AGENDA  
HAYDEN PLANNING COMMISSION  
THURSDAY, JUNE 13, 2024  
6:00 P.M.  
Join Zoom Meeting  
<https://us02web.zoom.us/j/89548614591>  
Meeting ID: 895 4861 4591  
HAYDEN TOWN HALL – 178 WEST JEFFERSON AVENUE, HAYDEN

**Planning Commission Agenda Item**

Scott Carlson, owner of lots 14, 15, 16, Valley View Business Park, doing business as SDC Ventures, LLC, proposes to develop this property as a live/work development for commercial/residential buildings to provide the need for residential units above commercial main level units.

# "CARLSON CORNER" CIVIL SITE PLAN

DRAWING: SHEET # **L1**

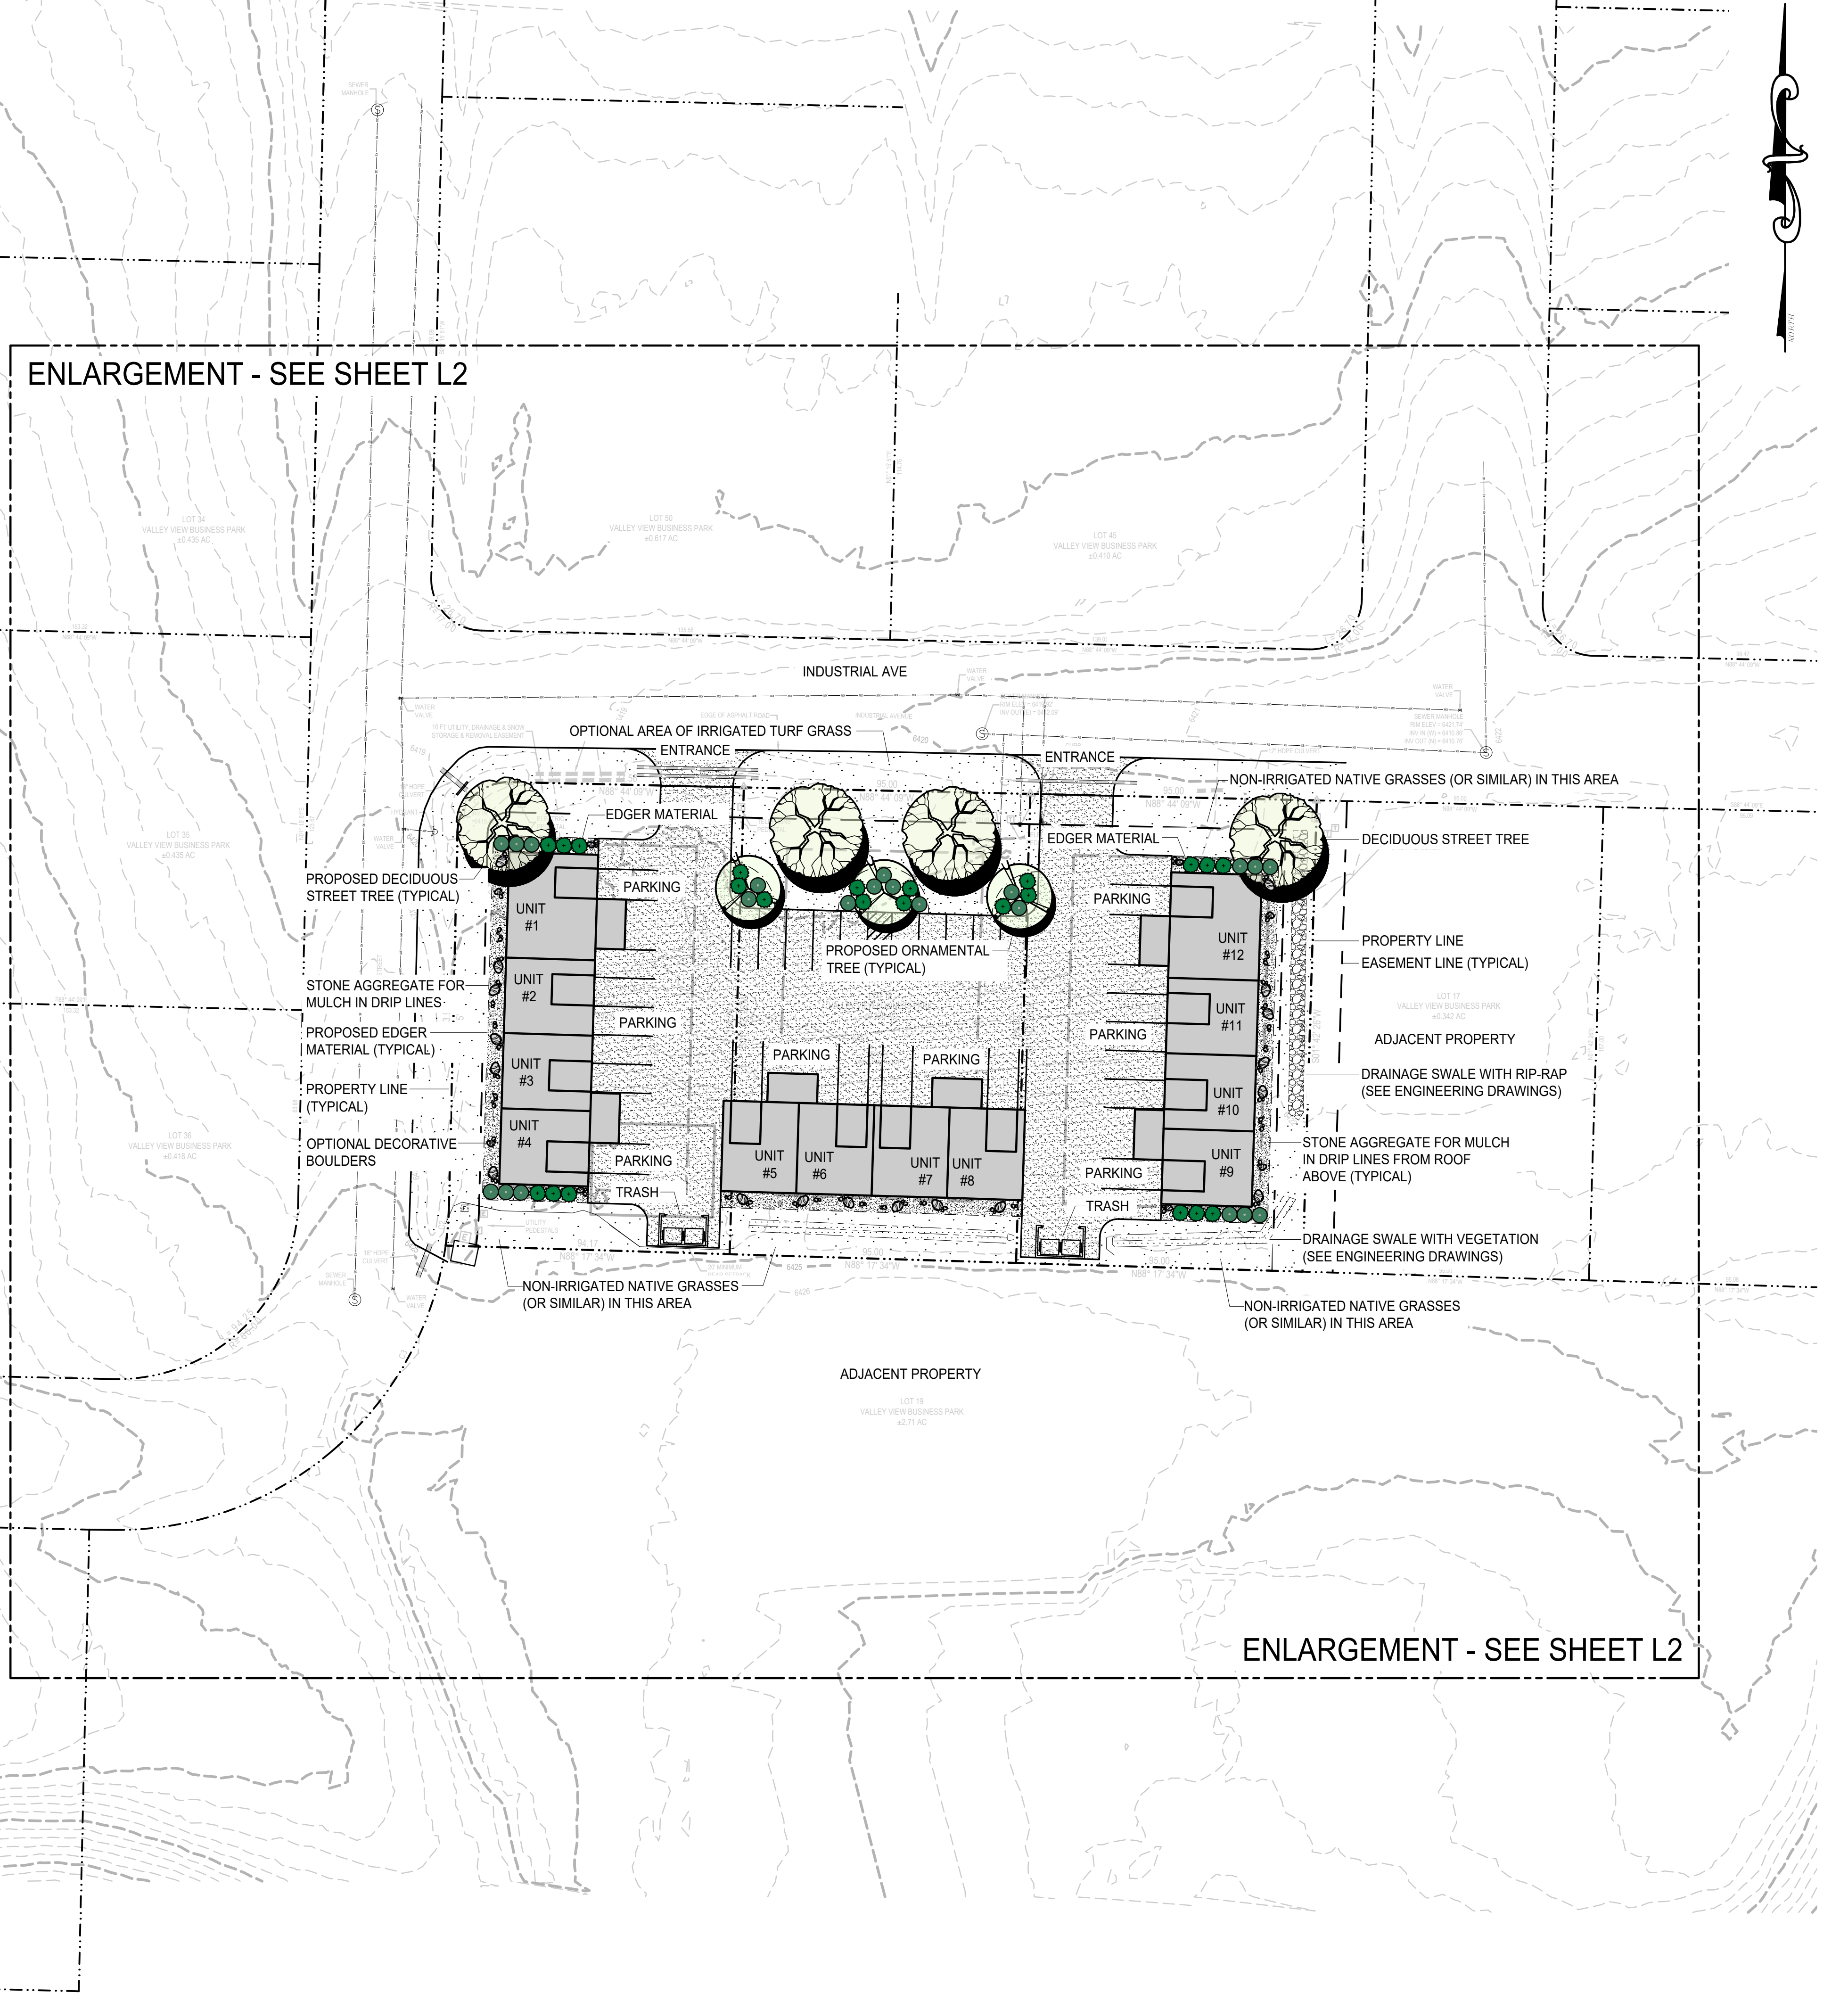
Complies		Section Standards
Yes		No	
<input checked="" type="checkbox"/> <u>Yes</u> <input type="checkbox"/> <u>No</u>			<p>(3) <b>Industrial development landscaping standards.</b> Landscape improvements within the I-1 and I-2 districts shall be designed to enhance the overall appearance of the development and to integrate the project with adjacent land uses and into the surrounding neighborhood. A minimum of fifteen (15) percent of the site (gross) shall be landscaped area. <i>Staff Comment: There site plan indicates that a 15% of the site area will be landscaped and an additional 20% of the site is open space. The required landscaping for the development is five (5) trees and twenty-two (22) shrubs</i></p>

- (6) **Parking Lot Landscaping Standards.** Parking lot landscaping is intended break up large expanses of pavement, create shade, buffer views of parking lots from adjacent streets and development and enhance the overall appearance of each project. All parking lots with ten (10) spaces or more shall be subject to these requirements. The developer or assigns shall provide:
- (i) Site trees – a minimum of one (1) tree per five (5) parking spaces. Group trees together in islands which are a minimum of ten (10) feet wide. Use the landscaping to break up large expanses of pavement and to create a tree canopy for summer shade. *Staff Comment: The site has 32 exterior parking space meaning that six (6) trees are required. The overall development is four (4) trees short of this requirement and a recommended condition of approval has been included.*

3. All exterior lighting must be downcast and opaquely shielded and in compliance with section 10.24.210 HDC.
4. Updated landscaping plans that include four (4) additional trees shall be submitted to staff for administrative approval prior to the issuance of the building permit.

DRAWING: **SITE PLAN**  
SHEET NO. **C3**

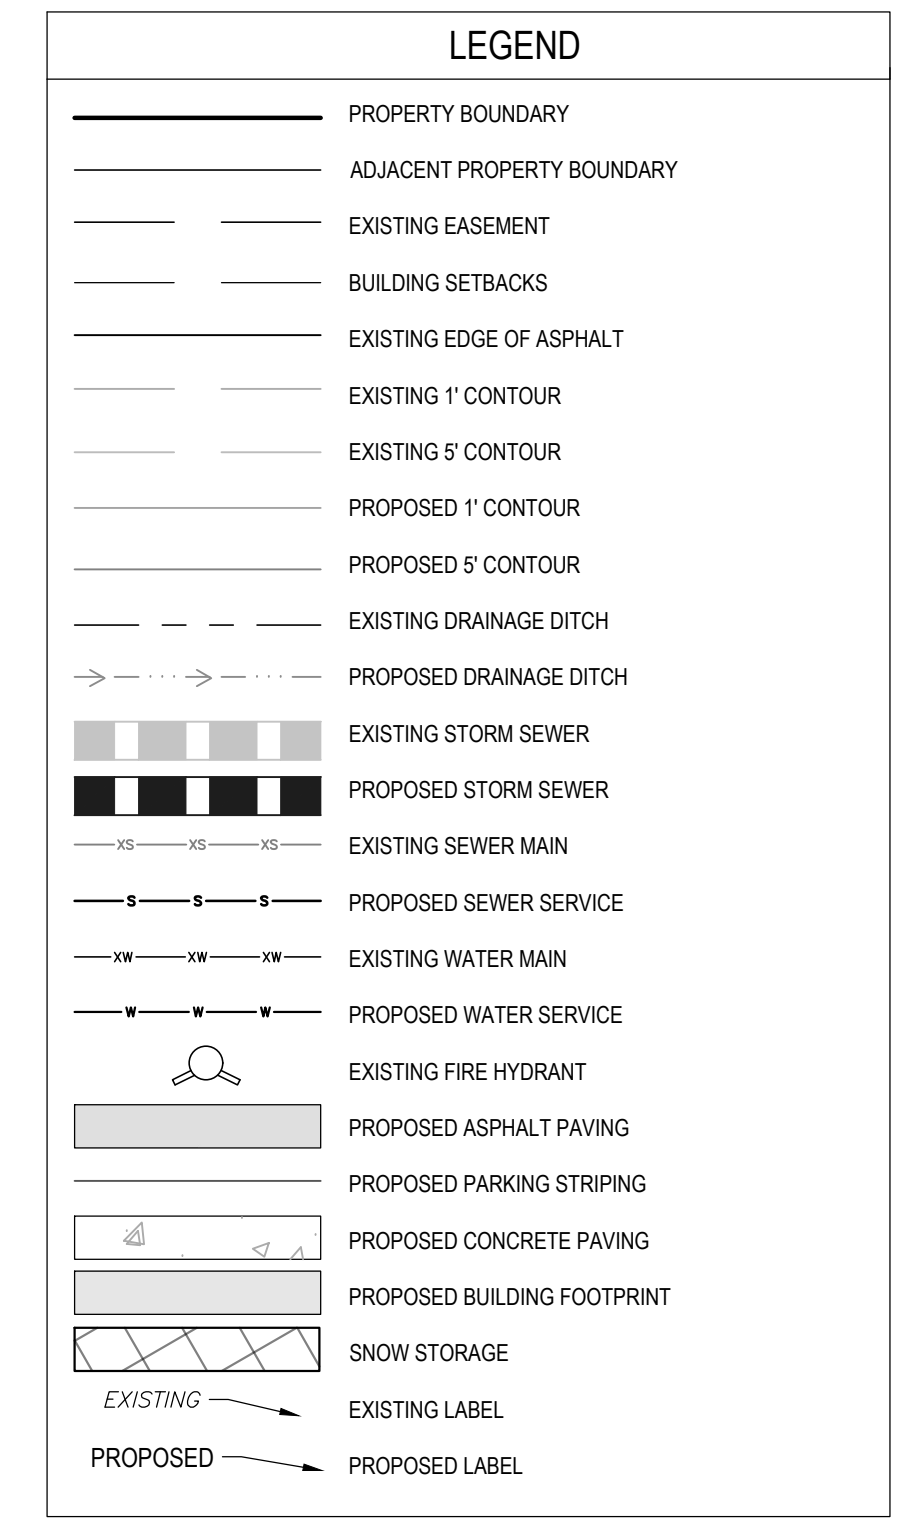
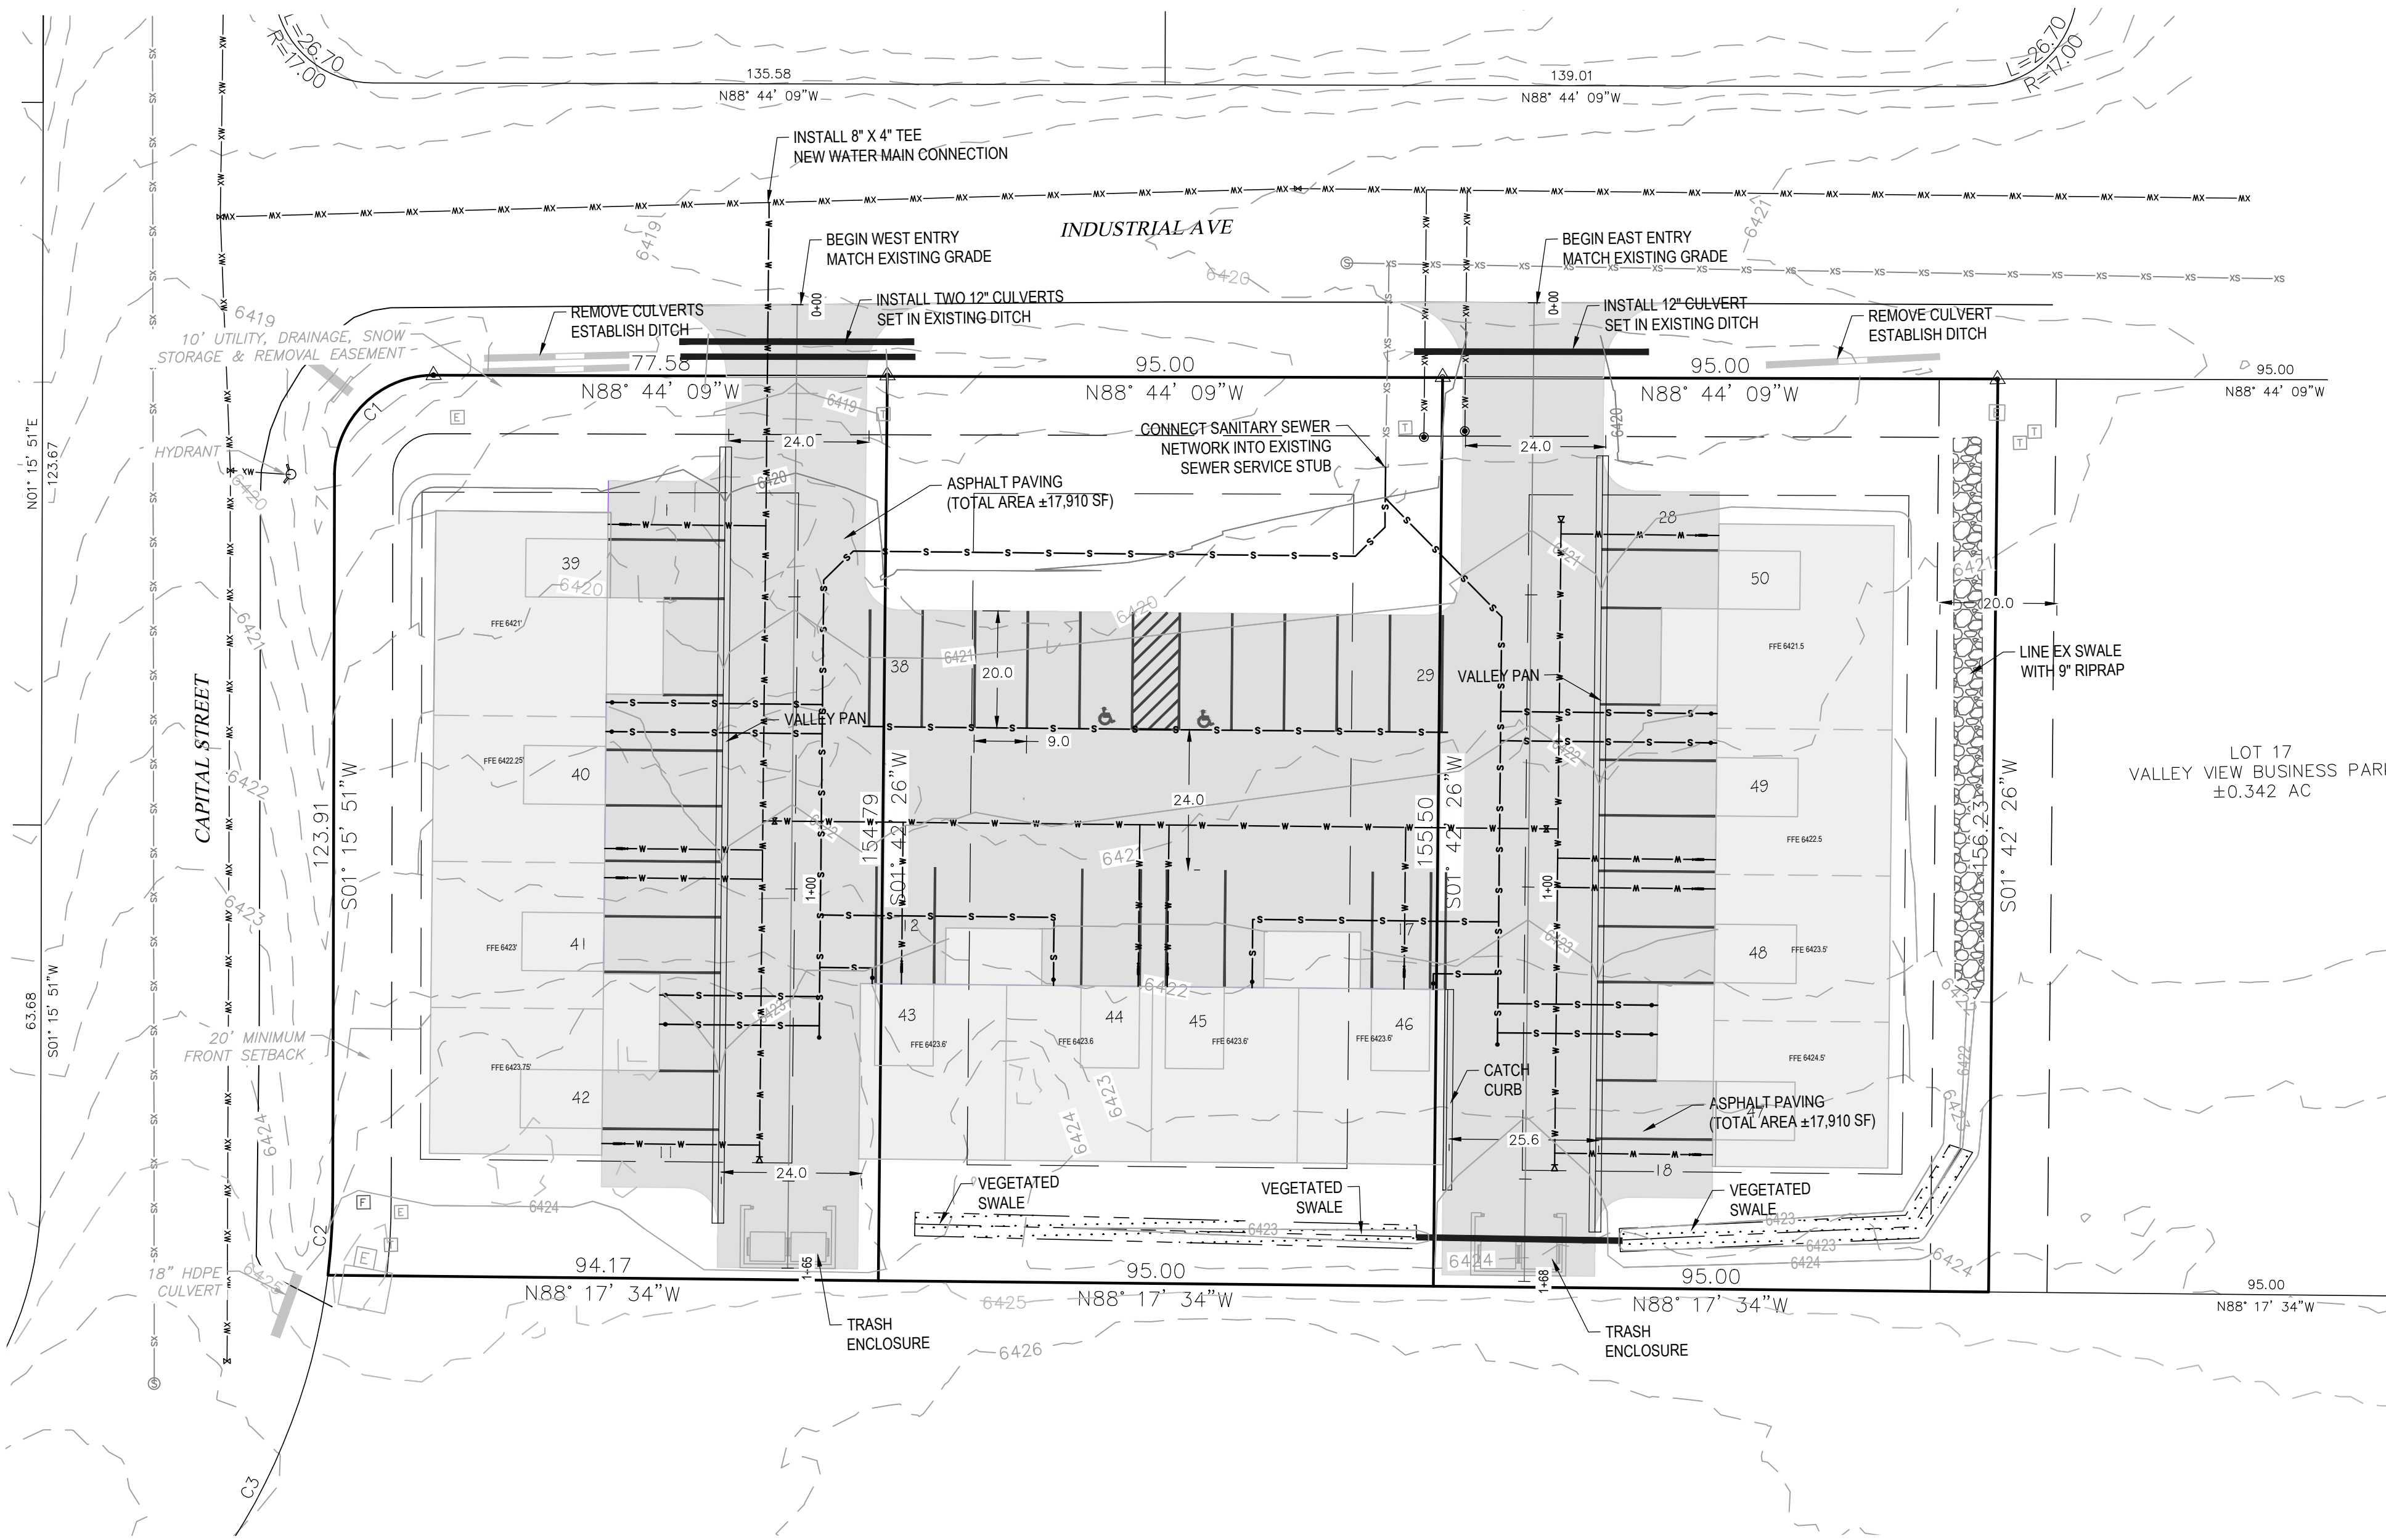
are ADA compliant and a further twelve (12) interior parking spaces within the work units. Twelve (12) of the exterior parking spaces require tandem parking in combination with the interior parking spaces and a condition of approval has been included to address the parking plan.

structure. *Staff comment: The site plan depicts a parking plan that is entirely onsite and will not require vehicles to back out onto the public road. The paved area is adequate for large vehicle circulation and deliveries associated with commercial/light industrial uses.*

8. **Striping.** All parking areas shall be striped to identify individual parking spaces. *Staff comment: Striping is shown on the site plan. A condition is recommended below that requires the parking area be striped in accordance with this standard.*

<input checked="" type="checkbox"/> <u>Yes</u> <input type="checkbox"/> <u>No</u>	<p>(4) Number of handicap parking spaces: Total parking spaces in lot: 26-50: 2 space required. <i>Staff Comment: Two (2) accessible parking space is provided in the center of the development.</i></p>
---	--
